Additional Information

Proposed Change 1J

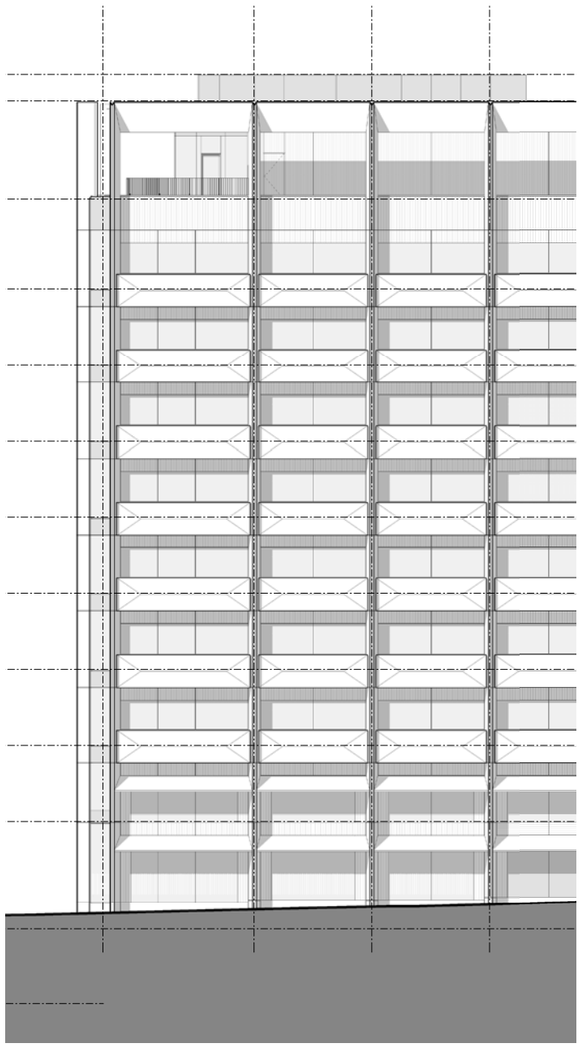
An additional mullion is proposed to be added to the end bays on the Medlock St and First St elevations.

This change is driven by the glass sizes in these bays at the ground floor which are large:

The approved glass size would be significantly heavier than the other glass and would exceed the limits of the system and its components, i.e. brackets, bolts, hooks etc.

Also the width and height requirements shown in the approved drawings exceed the glass processing restrictions of commercially available glass. (As the height is over 4m the width cannot typically exceed around 2.4m)

Delivering the approved proposal would result in a different appearance of the glass and frames as the rest of the ground floor.

Architecturally it is considered better to add an additional mullion to reduce the glass weights and have a consistent visual appearance,

In order to maintain the architectural design intent of lining through the mullions at the ground and upper floors, the upper floor have also been divided into three bays.

The proposed sizes of glass are 2.15m wide which is wider than the typical office glazing module of 1.5m and will appear generous.

Option 2 ☒

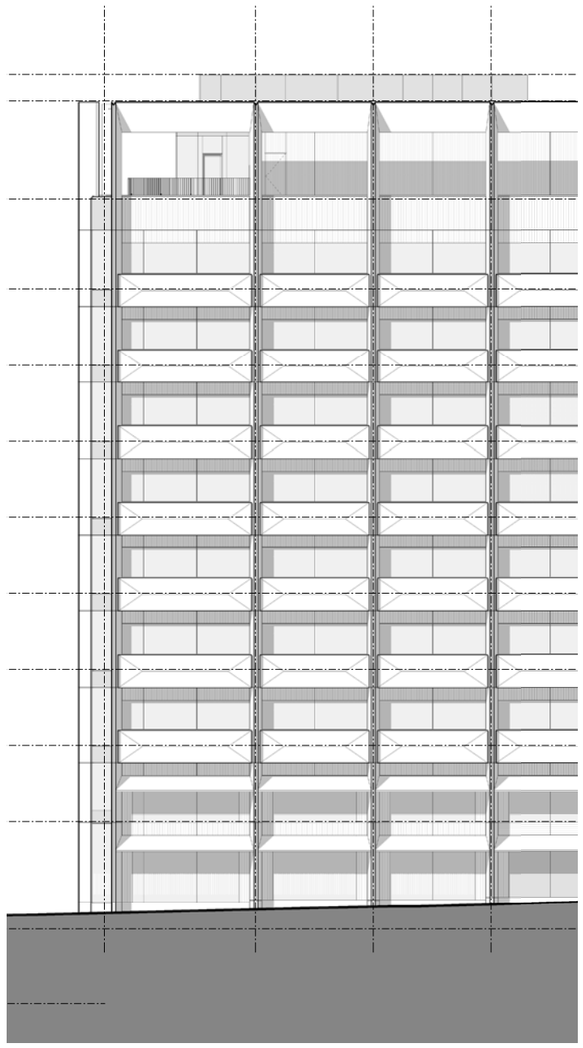
Option 1 ☒

Keeps the mullion in the location shown in the approved drawings and splits the lager pane into two equal sizes

Keeps the mullion in the location shown in the approved drawings and splits the lager pane into one piece of glazing of equal size and one smaller pane.

Option 3 ☑

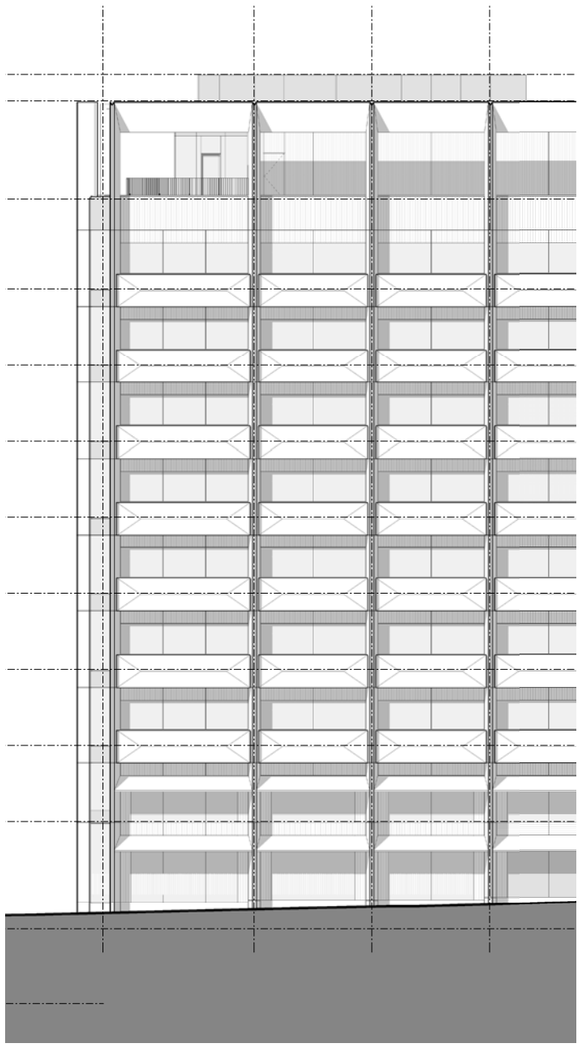
Splits the glazing into a bay of 3 equal widths,

Simple, elegant design.
